From: Mieke Vander Valk [mvandervalk@neb-one.gc.ca]
Sent: Monday, July 21, 2003 9:15 AM
To: CottP@DFO-MPO.GC.CA; HannaB@DFO-MPO.GC.CA; stephen.harbicht@ec.gc.ca; PromislowM@inac-ainc.gc.ca; YaxleyE@inac-ainc.gc.ca; eisc@jointsec.nt.ca; Alan Ehrlich; Vern Christensen, Executive Director
Cc: Lori Ann Boychuk
Subject: WesternGeco's response to MVEIRB's recommendations

NEB File: 9180-W730-2
MVEIRB File: EA02-002
11 July 2003

**WesternGeco Canada Mackenzie/Liard Rivers, NT 2D Seismic Program, 2004
Mackenzie Valley Environmental Impact Review Board Report of Environmental
Assessment - NEB Request for Comment**

Fig 1. Data set two sides of a shutdown zone from 2002 Test Program

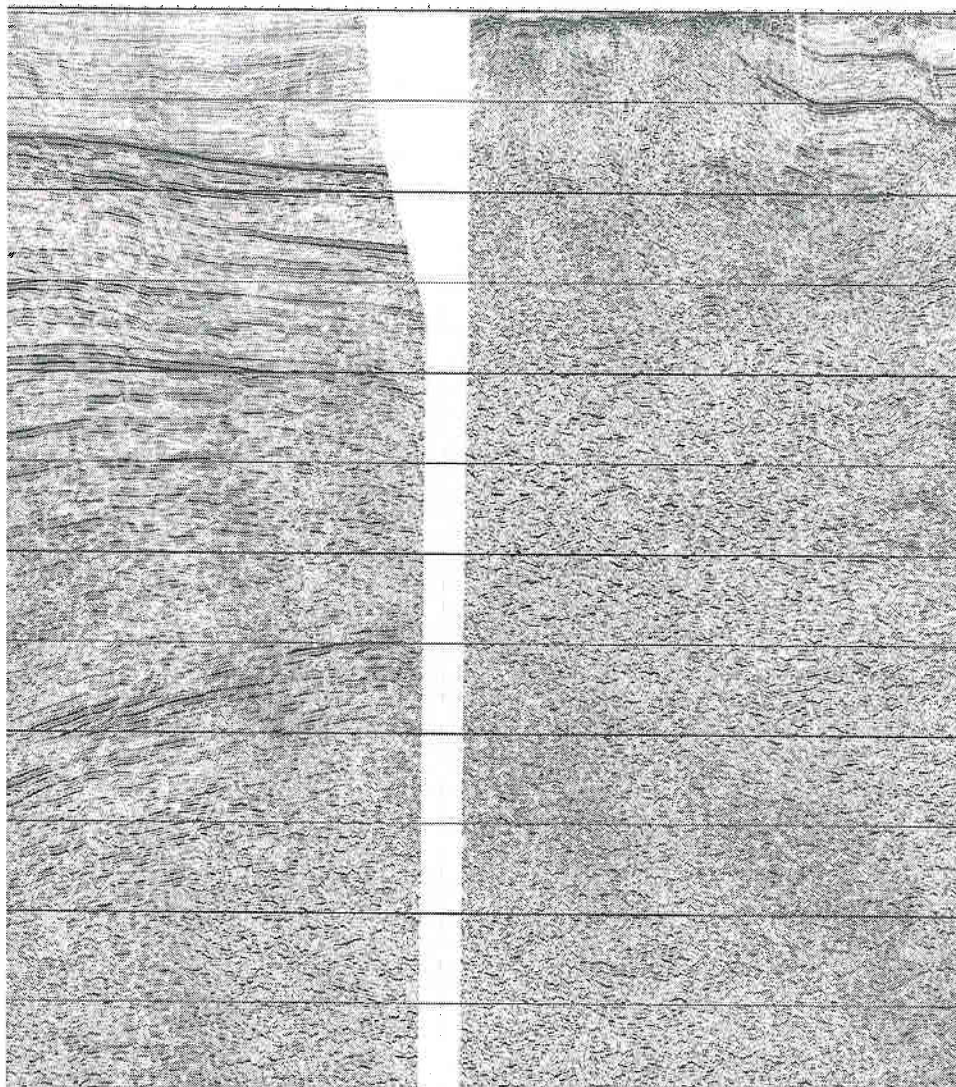
1. ***The Review Board recommends that WesternGeco submit a mitigation plan for DFO's approval, in order to prevent significant adverse environmental effect on fish by airguns. This will include unconditional shutdown in all areas of known sensitivity as identified by DFO in it's technical Report of 9th June, 2003 and the submission of June 13th, 2003. This mitigation plan shall be approved by DFO before the NEB issues an authorization for this development.***

Shutting down in areas identified by DFO as sensitive would seriously compromise the seismic data set. WesternGeco's objectives are to survey a continuous 2-D seismic line connecting the basins of the Delta, Norman Wells area and the Liard. Geology changes dramatically around tributaries and to understand what is happening we have to image these areas.

Figure 1 is a picture of a seismic record from an area on the Mackenzie River surveyed during the 2002 Test Program. The area in the middle of the data set where there is no data was not surveyed at DFO's request, as pre-cautionary mitigation during the 2002 Test Program and prior to obtaining the 2002 test results. WesternGeco believes that the results from the 2002 Test Program indicate that this mitigation is no longer valid. Furthermore, without imagining these areas we cannot see how, why or where the Geology changes. Gaps in the data such as the example given in Figure 1, makes the data set incomplete and less attractive to anyone wanting to understand the geology in the region. We estimate that an incomplete data set would devalue the Mackenzie Valley data by more

than \$3.5 Million Canadian Dollars. More importantly the missing data would never be recovered, and we would therefore never fully understand the Geology of the Mackenzie Valley.
